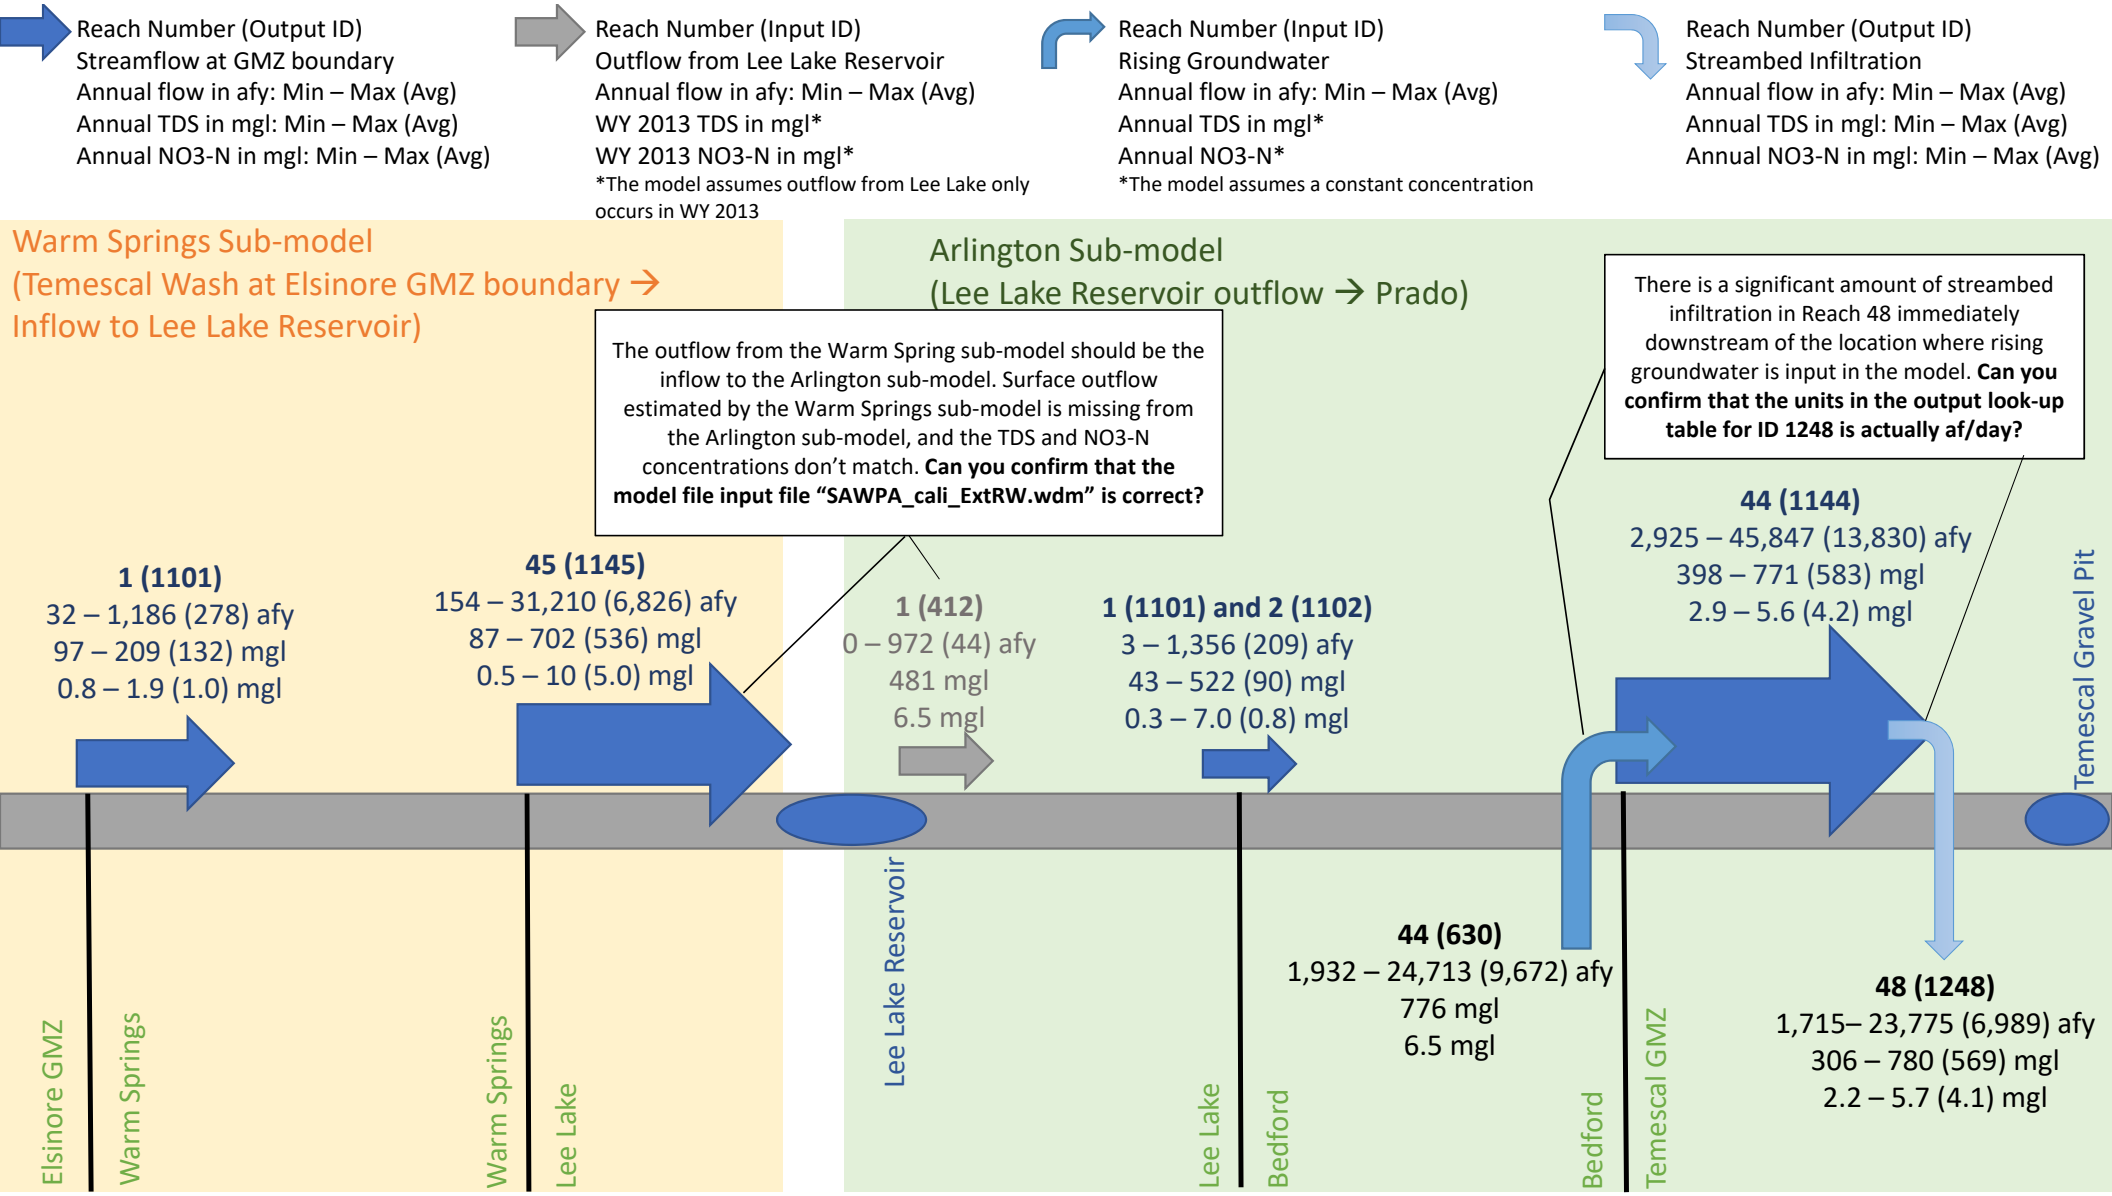
Reach Number (Output ID)
Streamflow at GMZ boundary
Annual flow in afy: Min – Max (Avg)
Annual TDS in mgl: Min – Max (Avg)
Annual NO3-N in mgl: Min – Max (Avg)
Reach Number (Input ID)
Outflow from Lee Lake Reservoir
Annual flow in afy: Min – Max (Avg)
WY 2013 TDS in mgl*
WY 2013 NO3-N in mgl*
*The model assumes outflow from Lee Lake only occurs in WY 2013
Reach Number (Input ID)
Rising Groundwater
Annual flow in afy: Min – Max (Avg)
Annual TDS in mgl*
Annual NO3-N*
*The model assumes a constant concentration
Reach Number (Output ID)
Streambed Infiltration
Annual flow in afy: Min – Max (Avg)
Annual TDS in mgl: Min – Max (Avg)
Annual NO3-N in mgl: Min – Max (Avg)
Warm Springs Sub-model
(Temescal Wash at Elsinore GMZ boundary → Inflow to Lee Lake Reservoir)
Arlington Sub-model
(Lee Lake Reservoir outflow → Prado)
The outflow from the Warm Spring sub-model should be the inflow to the Arlington sub-model. Surface outflow estimated by the Warm Springs sub-model is missing from the Arlington sub-model, and the TDS and NO3-N concentrations don't match. Can you confirm that the model file input file "SAWPA_cali_ExtRW.wdm" is correct?

There is a significant amount of streambed infiltration in Reach 48 immediately downstream of the location where rising groundwater is input in the model. Can you confirm that the units in the output look-up table for ID 1248 is actually af/day?
1 (1101)
32 – 1,186 (278) afy
97 – 209 (132) mgl
